Mr. John Young
ER2003-0546

August 27, 2003

**Response to
Request for Supplemental Information, Work Plan for Sandia Canyon and Cañada del Buey, Los
Alamos National Laboratory, NM0890010515, HWB-LANL-99-031**

Figure 3.4.3-5. Summary of environmental surveillance sampling of Sandia Canyon surface water for metals constituents

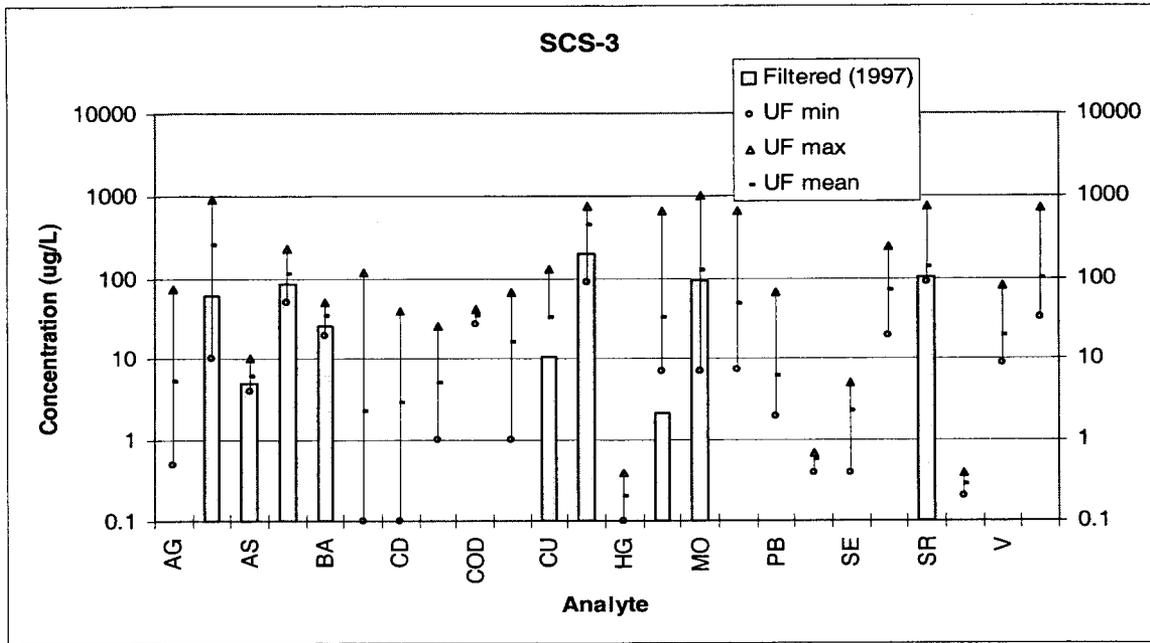
3 (2). *Figure 3.4.3-5 Summary of environmental surveillance sampling in Sandia Canyon for metal constituents, pg. 3-47:*

HWB Comment: Analytical data from filtered and non-filtered samples were combined together when representing the data using graphs. Analytical data from filtered and non-filtered samples should not be combined. Moreover, filtered data should be screened against the appropriate NMWQCC standards and non-filtered data should be screened against the appropriate NMWQCC standards, or the EPA MCL or health advisories. LANL shall construct separate graphs and tables for filtered and non-filtered samples. The right axis in graph SCS-3 has a different scale from the left axis, which defeats the purpose of the plot. LANL shall correct the scale of the axis and submit a revised plot.

3 (2). (1) Filtered and non-filtered data are separated on graphs using different symbols for each, so the first part of the comment is unclear. LANL sees value in putting both filtered and nonfiltered data on the same graphs to allow direct comparison, specifically to indicate where data in nonfiltered samples are elevated relative to filtered samples. (2) LANL suggests that adding standards to the graphs would make the figures too complicated, and there are only WQCC standards for a small subset of these metals. The plots are intended only to provide an overview of the range of concentrations measured to date for a large number of metals under the Environmental Surveillance Program. (3) LANL agrees that right axis on the graph for SCS-3 is inaccurate and should be the same as the left axis. A revised graph is included with this response as an attachment.
